UNITED STATES PATENT AND TRADEMARK OFFICE

Office Action Summary

09/819,201

CONNELLY, PAUL F.

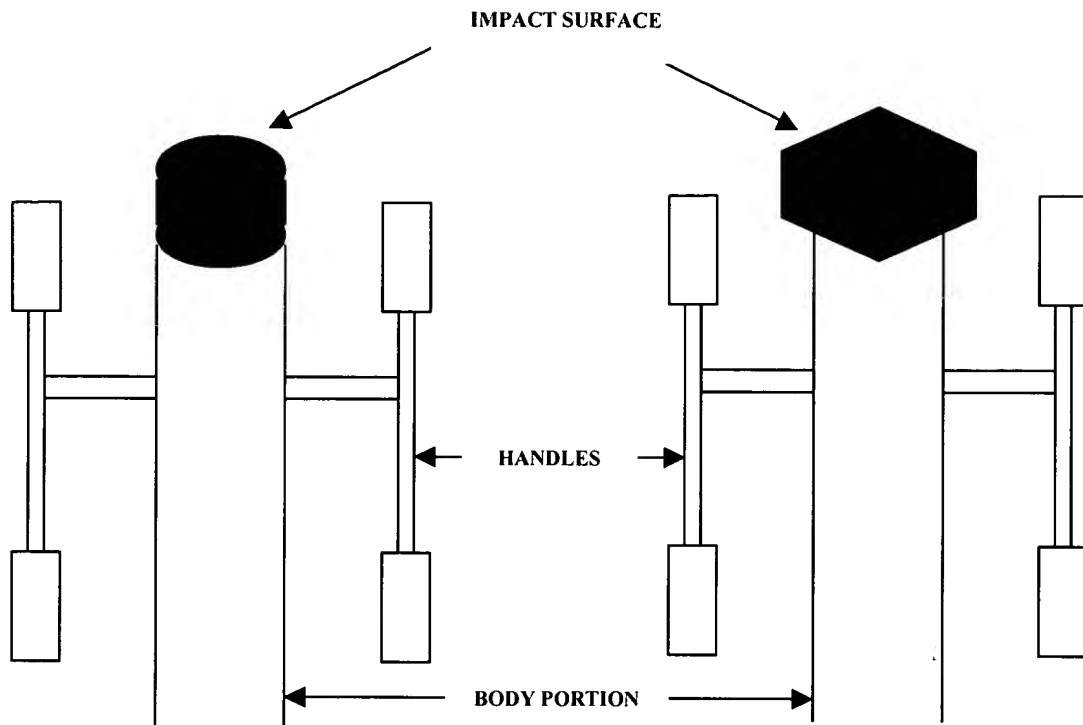
Deike discloses an impact member (63) having a circular shape, not a “rectangular” shape. It would have been obvious to one having ordinary skill in the art the time of the invention to modify the circular shape of the impact member to a rectangular shape, since applicant has not disclosed that such a shape solves any stated problem or is for any particular purpose and it appears that the invention would perform equally well with a circular impact member, as such a surface would likewise serve as an adequate surface for impact (see illustration below).
